DESIGN EXCELLENCE JURY PANEL MEETING | 6 JUNE 2022 | DEVELOPMENT APPLICATION JURY REVIEW

The purpose of the meeting is to review the DA drawings issued by Scott Carver dated Revision 1, dated 6.6.22 to determine whether the key design excellence features of the scheme are retained to enable Jury endorsement for the development application for 197 Church Street Parramatta.

FEBURARY – MARCH 2023 | DEVELOPMENT APPLICATION DESIGN EXCELLENCE JURY REVIEW

The purpose of this paper is to set out the Design Jury Review process for the development at 197 Church Street Parramatta, that has led to modest amendments to the plans.

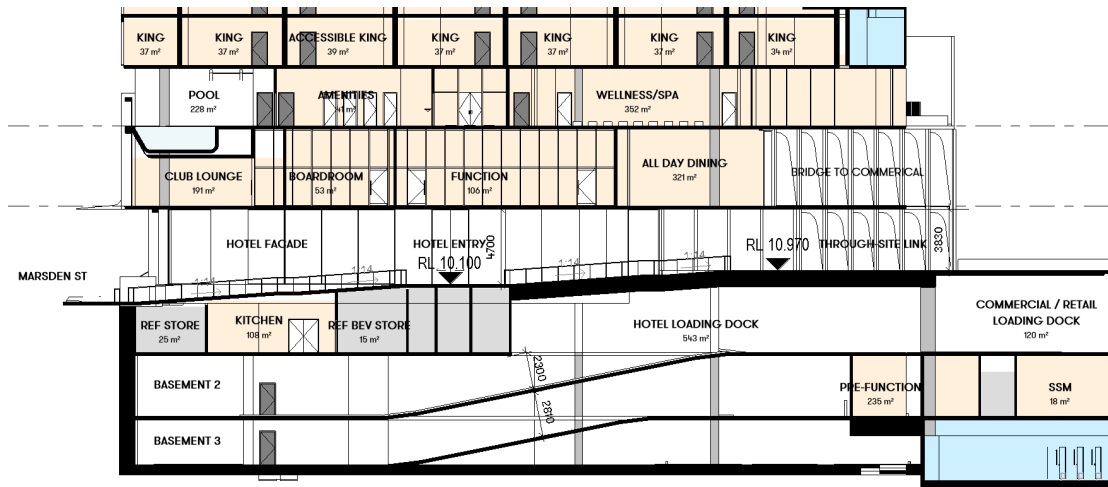
On 17 February 2023 the Design Jury responded in relation to the above sketch noted the improvements set out in the sketch and sought that more space still be given to the public domain. The Jury noted that the confluence of cars, drop off and pedestrian movements remained too compressed and that some consideration could be given to impacting on the ground level of hotel by reducing GFA.

On 28 February 2023 the Jury noted that they supported the proposal and that amended plans should be prepared for submission to the Council. The Jury noted that in the preparation of amended plans that –

- The Hotel colonnade planter was not necessary;
- A section would assist; and
- Turning diagrams and a review of the ramp grades should be undertaken.

On 27 February 2023 a revised sketch was sent to the Design Jury that –

- Allocated more space to the ground plane movement of pedestrians and vehicles;
- Reduced the GFA in the Hotel lobby; and
- Had been considered against traffic and structural requirements.
